ADDENDUM # 015

RE: Cherokee Nation Entertainment
Tahlequah Casino

Addendum 15

PROJECT: CNE Tahlequah Casino

02/27/18
17-06
C2.02b
UTILITY PLAN INSET

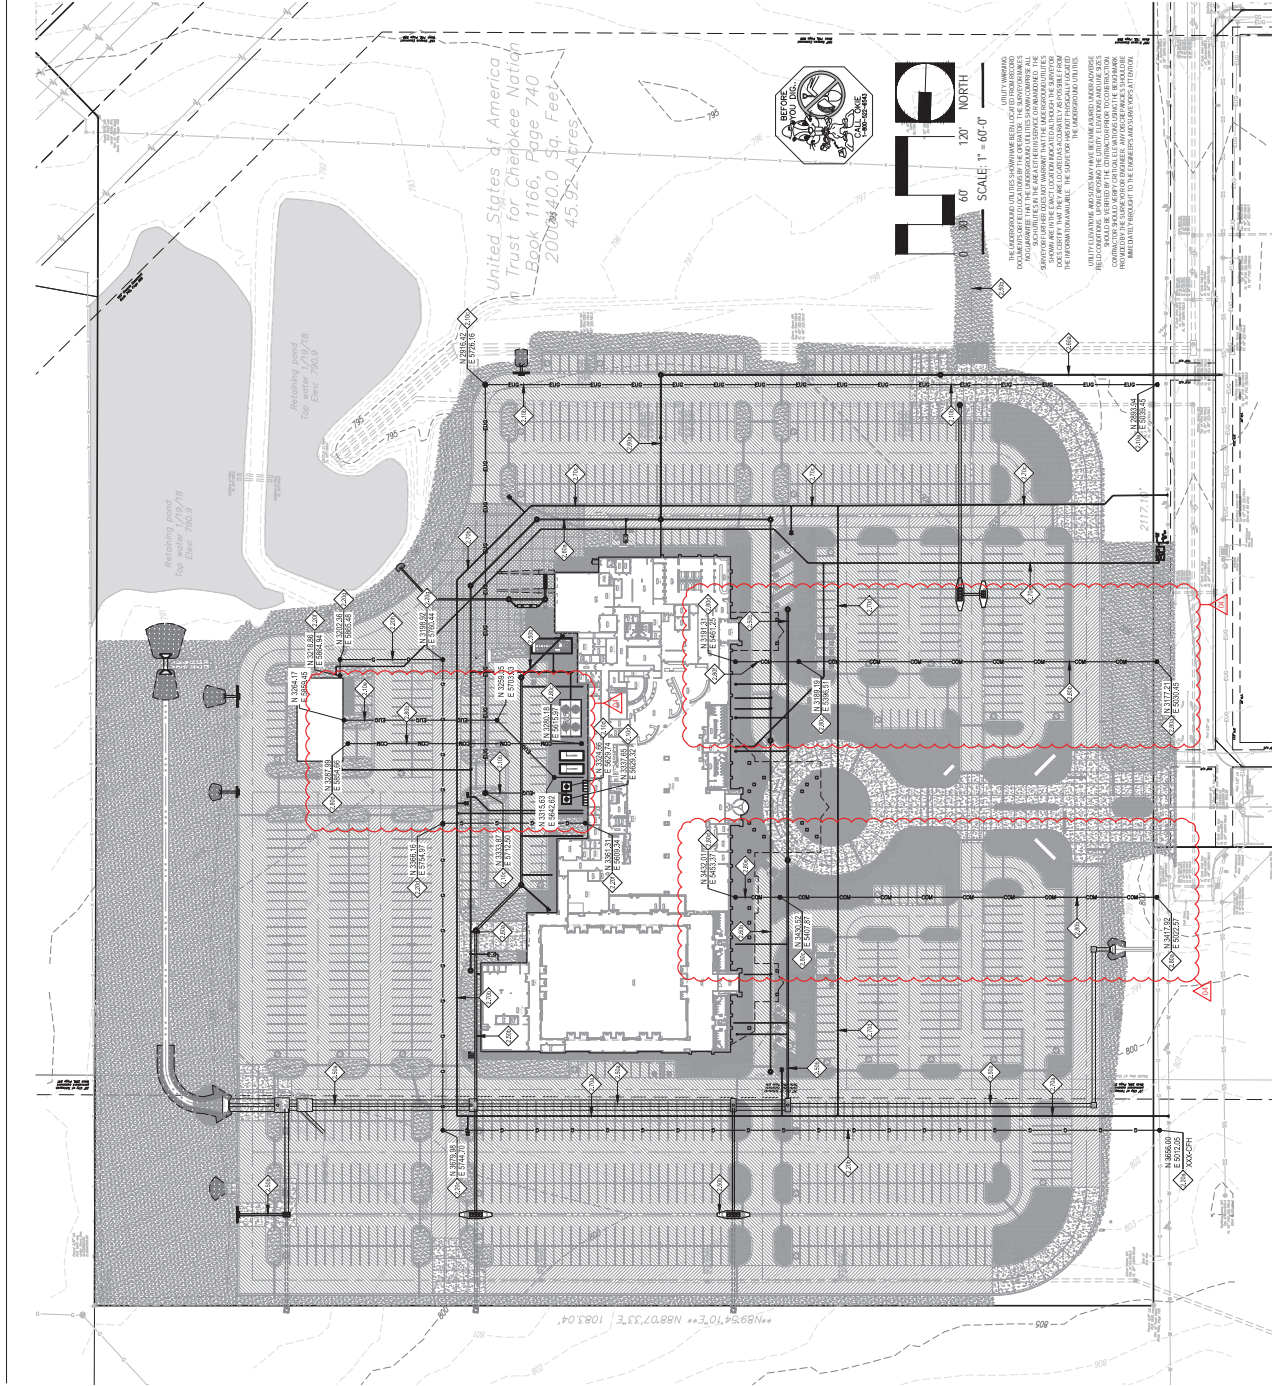
1. Routing of proposed telecommunication services has been adjusted per comments from Owner and IT Consultant.

- Item 1. Refer to Drawings: As shown below replace the entire drawing sheet with the revised drawings sheet included in this addendum as an attachment.

Number	Name	Issue Date
C2.02b	UTILITY PLAN INDEX	July 13, 2018
